Docket Item # 14 & 15  
BAR CASE # 2009-0301 &  
2010-0011

BAR Meeting  
December 1, 2010

**ISSUE:** Permit to Demolish/Encapsulate & Addition

**LOCATION:** 626 South Lee Street

Existing Front Elevation

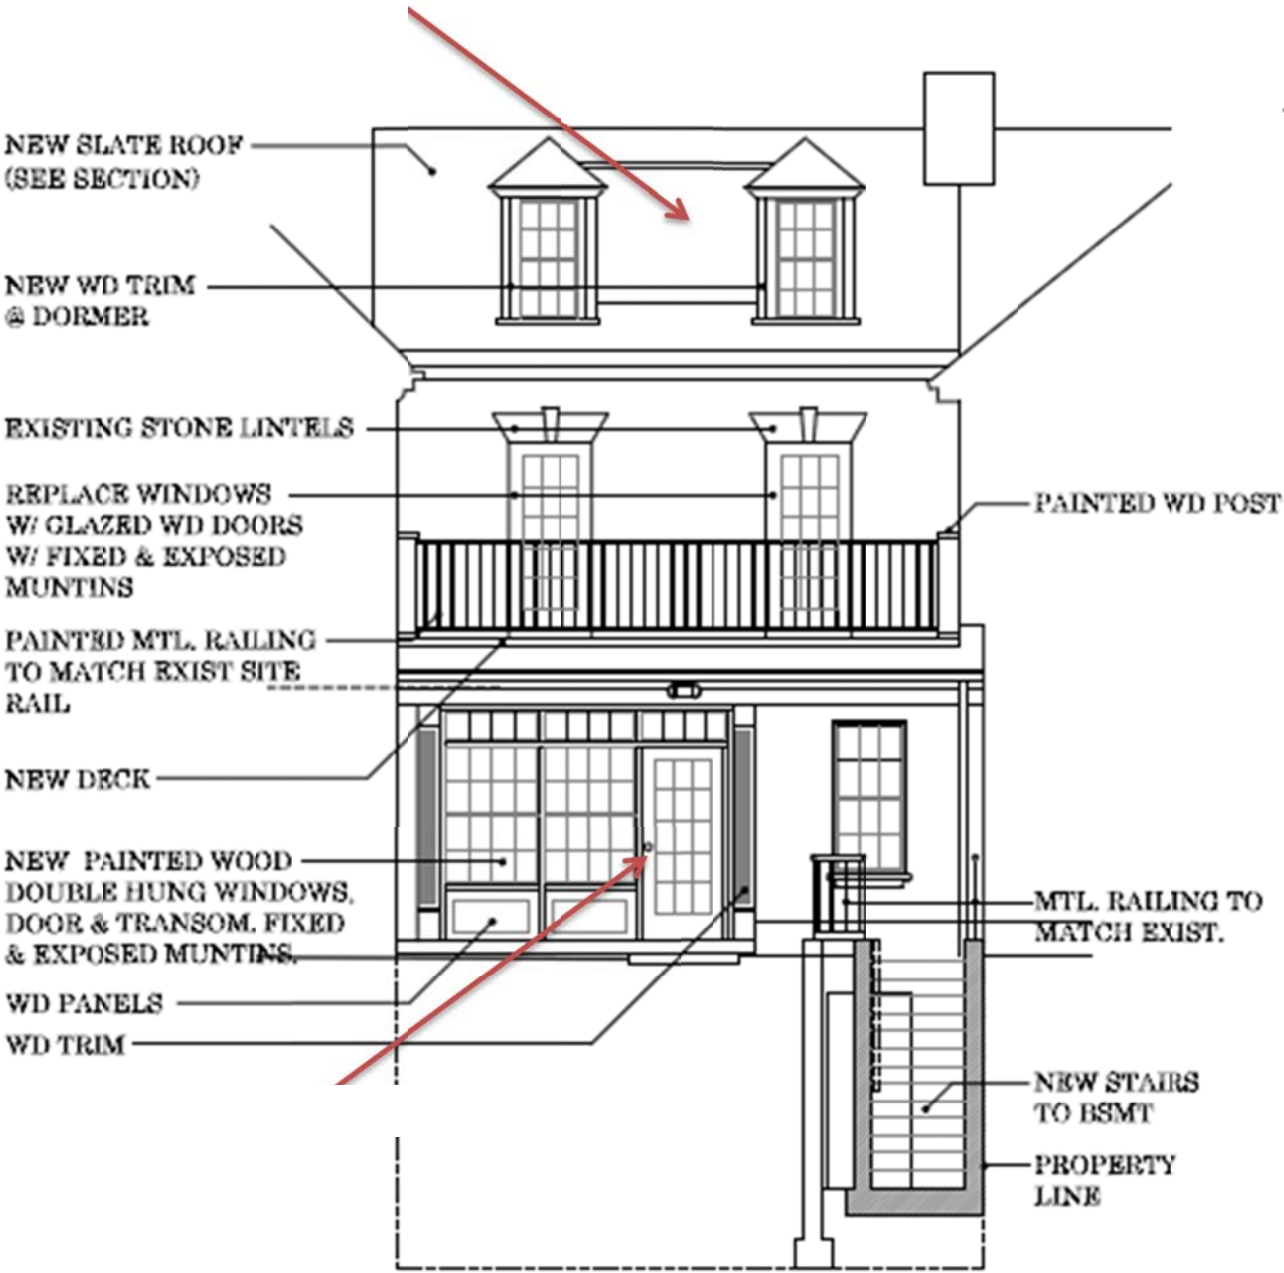
The existing front entrance to 626 S. Lee Street is through a one story, shed-roof screened porch. The applicant proposes to replace the screen porch with double hung painted wood windows and a French door flanked by fluted pilasters. The existing copper shed roof over the entry porch

will be replaced with a second floor deck with a simple metal railing and the windows replaced with French doors. The space between the two existing hip roof dormers will be filled in with a large, shed roof clad in matching slate. A new stair to the basement will be added adjacent to the main entrance to the dwelling and two 8" tall masonry planters are proposed in the public right-of-way adjacent to the sidewalk.

Staff believes that the proposed alterations to the front porch and dormer are architecturally inappropriate for this dwelling and are incompatible with the formal character of the adjacent houses. It is highly unusual to have the main entrance of a three story brick and slate roof Colonial Revival style townhouse in Alexandria via what appears to be an enclosed, side utility porch. For instance, even the light fixture shown above the door is characteristic of a utility fixture and not a Colonial Revival style entrance. The informal, asymmetrical layout of the first floor façade contrasts strongly with the traditional symmetry of the existing windows and dormers above. The fluted pilasters shown on either side of the glassed-in porch lack capitals and bases and do not continue to the south end of the porch, leaving the beam visually unsupported. Staff suggests that the design of the first floor be symmetrical in a Colonial Revival style reflecting the upper floors of this house and that it be either be a columned porch filled with windows across its entire width or a brick first floor façade with pilasters and a Georgian style doorway flanked by punched windows. The part glass and part brick proposal with randomly applied pilasters is neither fish nor fowl and is not a traditional Alexandria street facade. The new porch railing at the second floor should then reflect the architectural order of the first floor using a Neo-Classical vocabulary.

Staff, therefore, recommends a restudy of the front elevation to:

1. Eliminate the basement stairs;
2. Create a more symmetrical and formal Colonial Revival style front façade;
3. Leave the existing front dormers and slate roof in place; and
4. Push the mass of the third floor addition toward the east (rear).

PROPOSED ELEVATIONS

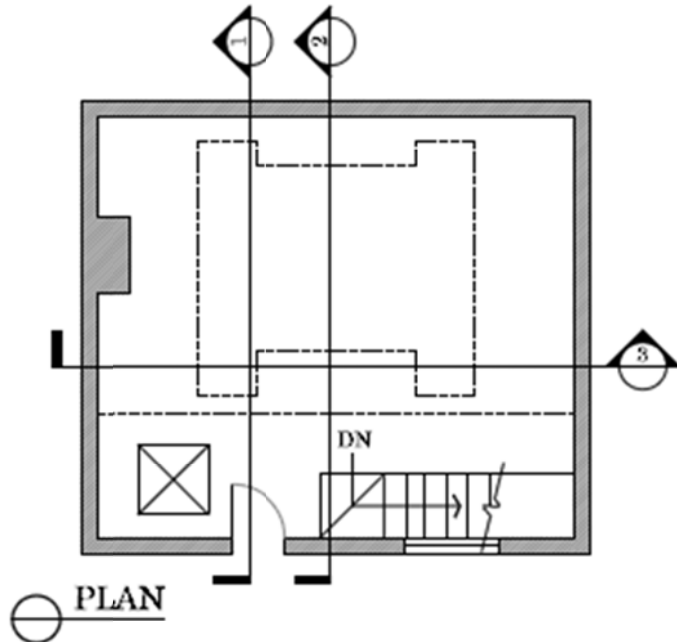
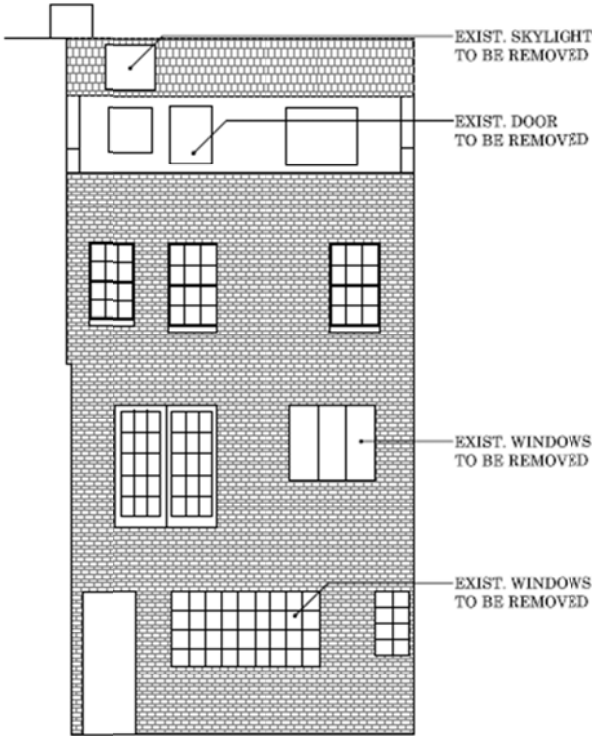
The newels, or plinths, of the second floor porch railing would normally be aligned over columns below and the width would be subdivided into two or three bays with turned balusters between. The proposed utilitarian iron rail without these intermediate visual supports is insubstantial and lacks the visual weight of the main body of the house. It is also unusual to have French doors on the front elevation of an Alexandria townhouse. These less formal doors are more common on rear facades or sunrooms.

The proposed basement entry stair is also something which is more commonly associated with a rear, or service, elevation. Where they do exist on the front, they are smaller and more typically used on vernacular dwellings to enter a raised basement. This basement level of this dwelling is easily accessed at grade in the rear and Staff does not believe access to the basement from Lee Street is worth the loss of garden space or the adverse architectural impact on the main entrance to the house.

Finally, the Board has generally opposed any type of shed roof dormers on Colonial Revival style buildings because they are stylistically inappropriate. The existing dormers are well proportioned and detailed and would not have the same handsome appearance if the infill were constructed. The architect has indicated that the existing dormers would have to be demolished

and rebuilt to construct the new roof structure. If the infill is approved and the dormers are demolished, staff recommends that the existing dormer detailing be matched exactly. Where large dormers have been constructed on the street façade of a building in the past, the Board has almost always later agreed that they have not been visually successful and said that several past examples farther south on Lee Street should not be repeated. In this case, there is a significant amount of space available above the existing flat roof on the east side of the house, facing the Potomac River and Staff believes that it may be possible to expand a third floor addition in this direction.

REAR ELEVATION

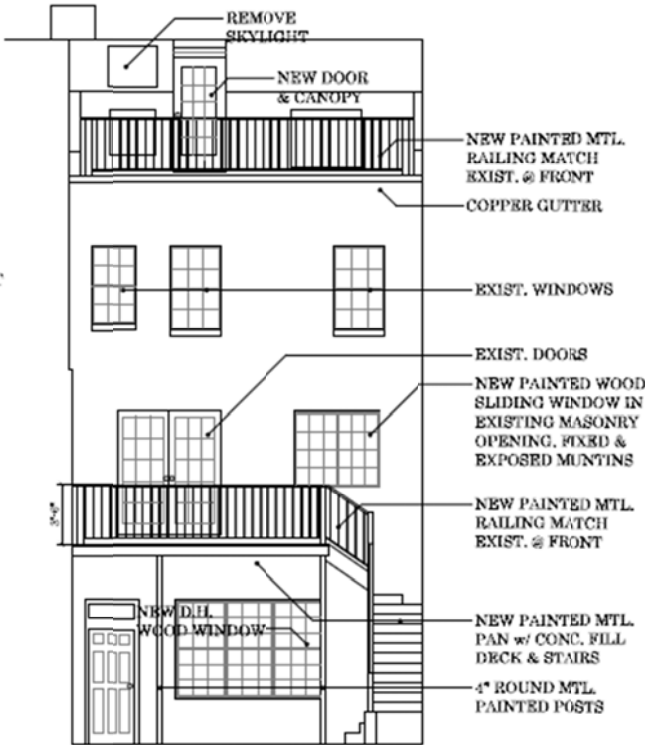
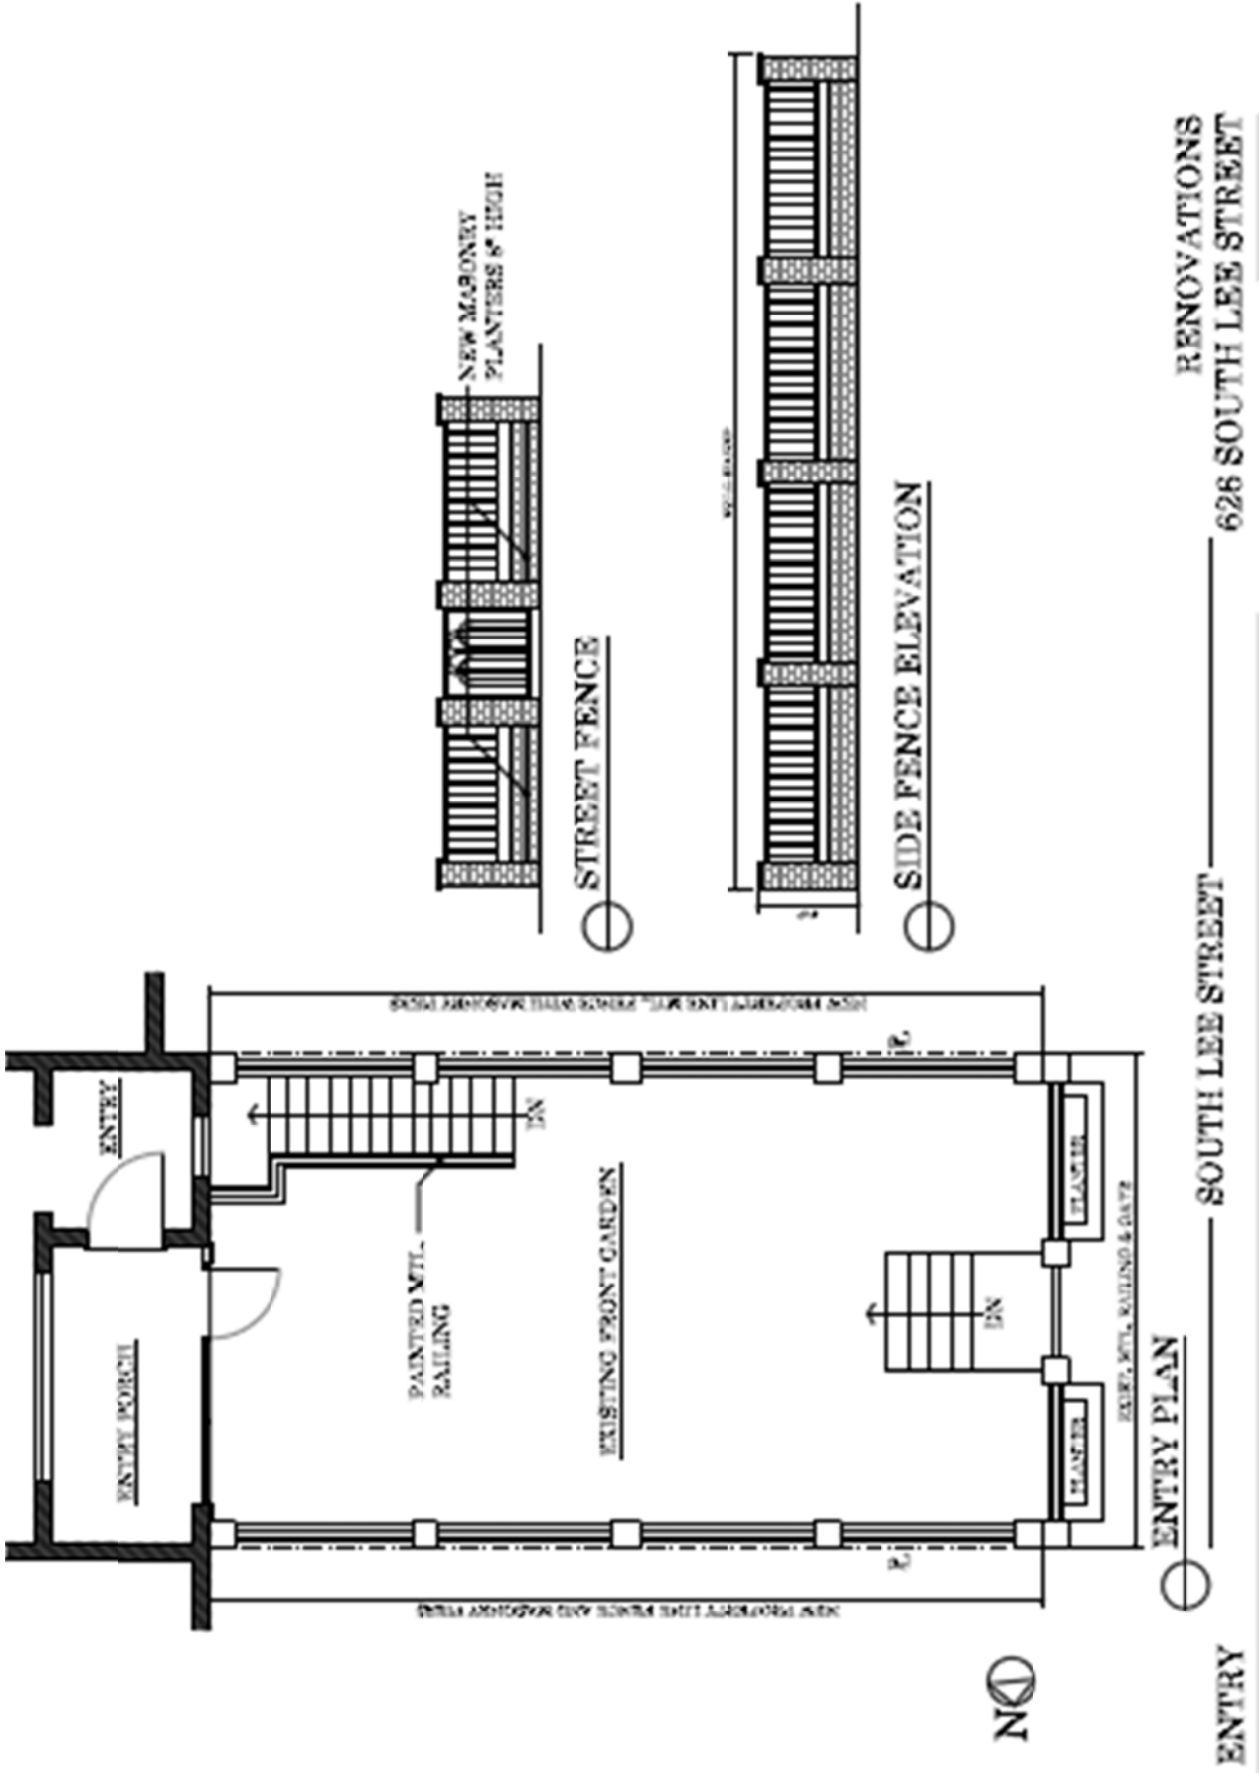
The far less formal rear elevation is difficult to see behind the garage and existing trees, though it would be much more visible from Franklin St. and Pommander Walk in the future if the trees were to die. Nevertheless, it is historically common for the rear elevation to use less expensive materials and to be more irregular than the front. Staff has no objection to metal railings on the suburban style decks at the first floor or the fourth floor roof deck, as they are minimally visible. However, like the railings on the front elevation, these railings still need more visually substantial and architecturally integrated corner and intermediate posts. As noted above, Staff believes that it would be more appropriate to enclose a portion of the existing flat roof area on the top floor than to expand toward Lee Street. This is a common way to enlarge attic rooms and several similar applications have recently been approved nearby.
